# **Intel® Mobile Celeron™ Processor Specification Update**

Release Date: June 1999

Order Number: 244444-005

Figure 2. Workaround Flowchart: SMBALERT#-Driven System

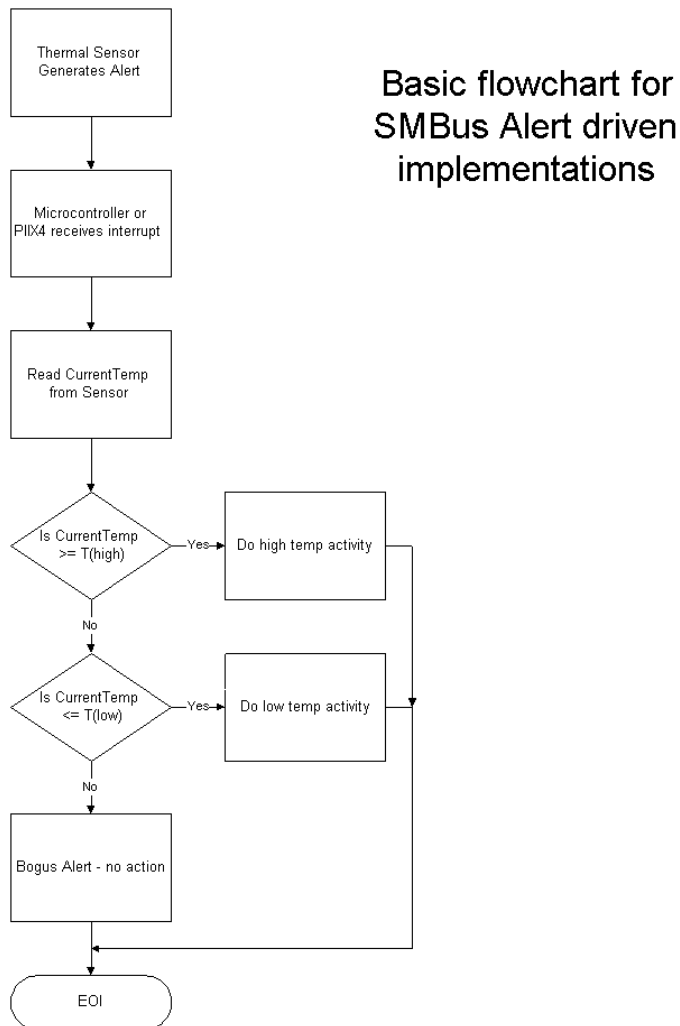
**PROBLEM:** The Intel Celeron Processor Mobile Module has a thermal sensor that monitors the processor core's temperature. Please note that desktop systems could have a similar thermal device. The thermal sensor asserts SMBALERT# if the processor temperature exceeds the temperature limits set in the Alarm Threshold Registers ( $T_{HIGH}$ ,  $T_{LOW}$ ). It also sets the corresponding Status Register bits to identify the cause of the interrupt. Figure 1 gives one example of the how the SMBALERT# signal could be used in a system.

**WORKAROUND:** Three different (mutually exclusive) workarounds are possible:

1. Before servicing an interrupt from the thermal sensor, read and compare the processor thermal reading with the threshold limits ( $T_{HIGH}$  or  $T_{LOW}$ ). Figures 2 and 3 provide basic flowcharts for the implementation of this workaround in an interrupt driven system.
2. If the firmware implemented polls the Status Register only, then before taking any action, re-read the temperature register and do a comparison with the alarm threshold limits ( $T_{HIGH}$  or  $T_{LOW}$ ) to determine if the value is actually still within the temperature window.
3. Use a temperature polling scheme to monitor the processor temperature.

**Figure 5.3. Surface-Mount BGA1 Package - Top and Side View**

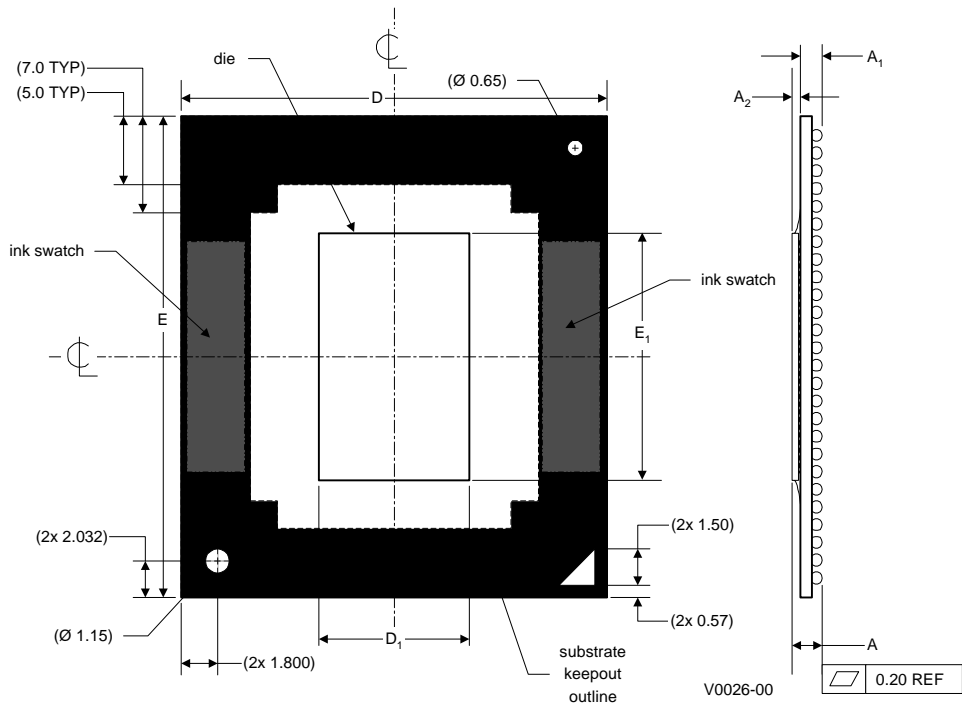
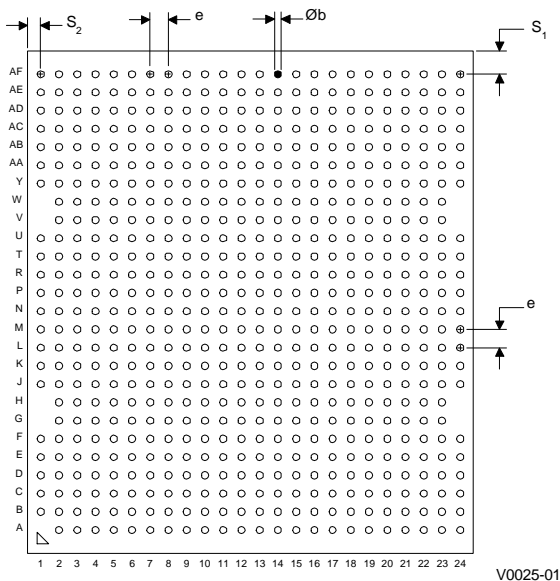
The following table and figures show the updated mechanical specifications for the BGA1 package, listed as Table 5.2, Figure 5.3 and 5.4, respectively, in the *Intel® Mobile Celeron™ Processor in BGA Package at 333 MHz, 300 MHz and 266 MHz* datasheet.

1. The number shown here is different from that in last month's specification update. The maximum reference number is used.
